Subject: DTE Electric Company Response to NRC Request for Additional Information
Letter No. 87

Response to RAI Letter No. 87
(eRAI Tracking No. 7170)

RAI Question No. 02.05.02-21

Figure 1 –Comparison of the Adjusted LR, IR, and UR Shear Wave Velocity Profiles (Black, Dashed/Dotted Lines) with the Vogtle ESP Shear Wave Velocity Profiles from Tables 2.5.4-10 and 2.5.4-10a of Reference 1

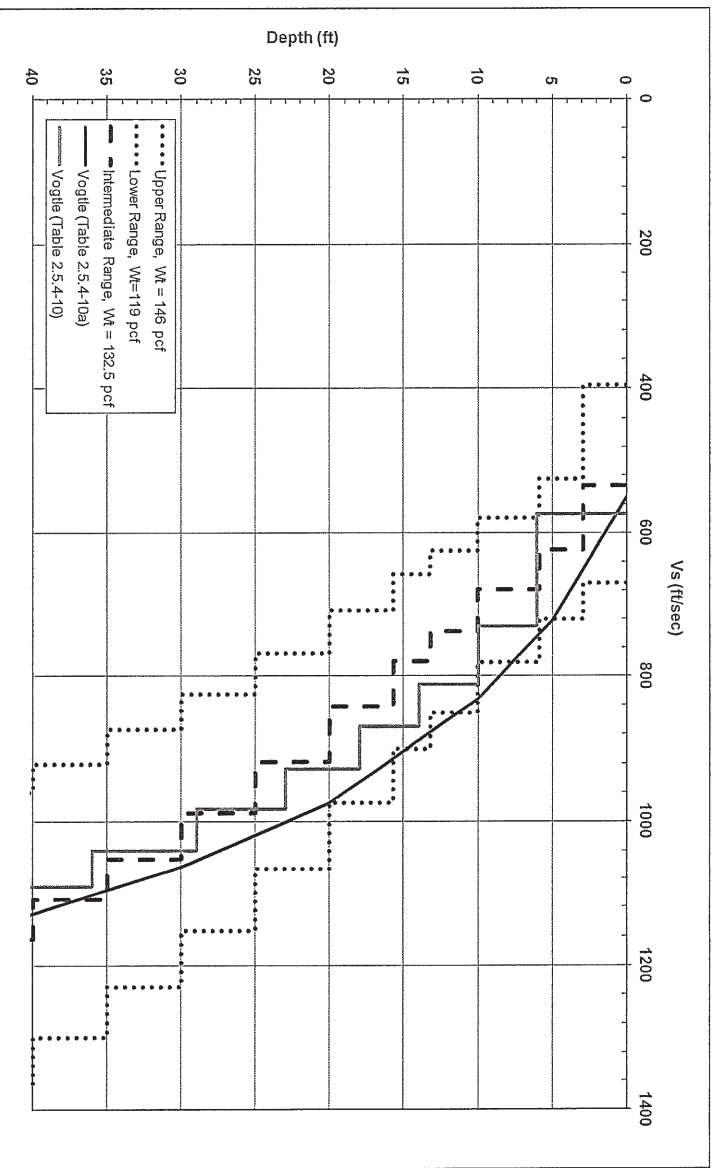
- (e) FSAR Figure 3.7.1-210 shows the site response logic tree used to compute the mean amplification functions. According to this figure, the LR velocity profile (paired with the Meng (2003) shear modulus reduction and damping curves) is assigned a weight of 0.15, the LR velocity profile (paired with the average of the UR and LR curves) is assigned a weight of 0.50, and the UR velocity profile (paired with the EPRI (1993) curves) is assigned a weight of 0.35. Please provide a justification for this weighting scheme.

Figure 1 demonstrates that the Vogtle ESP shear wave velocity profiles are most similar to the adjusted Fermi 3 IR shear wave velocity profile based on the following observations

1. The Vogtle ESP shear wave velocity profile in Table 2.5.4-10 exceeds the adjusted Fermi 3 IR shear wave velocity profile from about 6 to 25 feet below grade by up to about 75 feet per second.

2. From a depth of 25 to 40 feet, the Vogtle ESP shear wave velocity profile in Table 2.5.4-10 is very similar to the adjusted Fermi 3 IR profile, being only up to about 20 feet per second less than the adjusted Fermi 3 IR shear wave velocity.

3. The Vogtle ESP shear wave velocity profile in Table 2.5.4-10a exceeds the adjusted Fermi 3 IR shear wave velocity profile from about 3 to 30 feet below grade by up to about 100 feet per second.

4. From a depth of 30 to 40 feet, the Vogtle ESP shear wave velocity profile in Table 2.5.4-10a is very similar to the adjusted Fermi 3 IR shear wave velocity profile.

5. At depths shallower than 20 feet, both Vogtle ESP shear wave velocity profiles approach the adjusted Fermi 3 UR shear wave velocity profile.
6. The Vogtle ESP shear wave velocity profile in Table 2.5.4-10a is similar to the adjusted Fermi 3 UR shear wave velocity profile between about 6 and 15 feet below grade.

7. Both of the Vogtle ESP shear wave velocity profiles are greater than the adjusted Fermi 3 LR shear wave velocity profile.

This comparison demonstrates that the estimated shear wave velocities for the adjusted Fermi 3 site are reasonably consistent with measured shear wave velocities in the Vogtle ESP, and that the measured shear wave velocities in the Vogtle ESP are most similar to the adjusted Fermi 3 IR shear wave velocity profile at most depths. At select depths, the measured shear wave velocities in the Vogtle ESP are also similar to the adjusted Fermi 3 UR shear wave velocity profile. This comparison also indicates the assigned weights, which assign a higher weight to the Fermi 3 IR site response analysis profile, an intermediate weight to the UR site response analysis profile, and a lower weight to the LR site response analysis profile, are reasonable.
